To Office: Bridges & Structures

Ref. No.: 521.1

Subject: MM No. 77 Changes to new BTC and BTB Beams

BTC BEAM CROSS  
SECTION

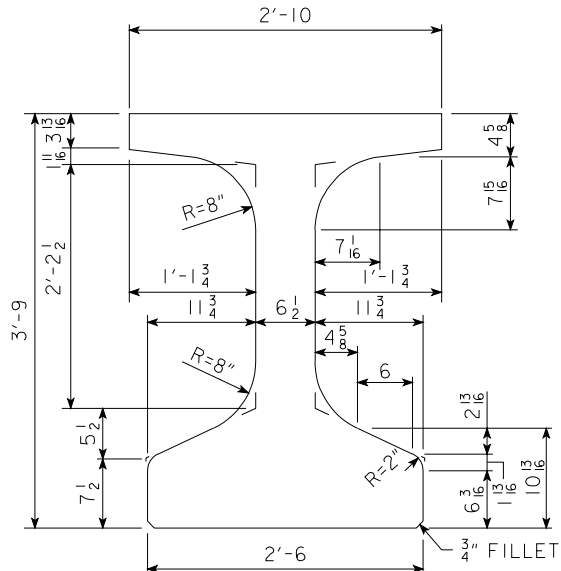
To reduce beam weight the width of the top flange was reduced from 48 inches to 34 inches. See attached sheet showing modified sections.

Because of changes in the AASHTO LRFD specifications and the use of the narrower flange width, the top flange edge bars (5c1 and 5c4) were eliminated.

The block out detail was eliminated and the flange width will be constant along the entire length of the beam.
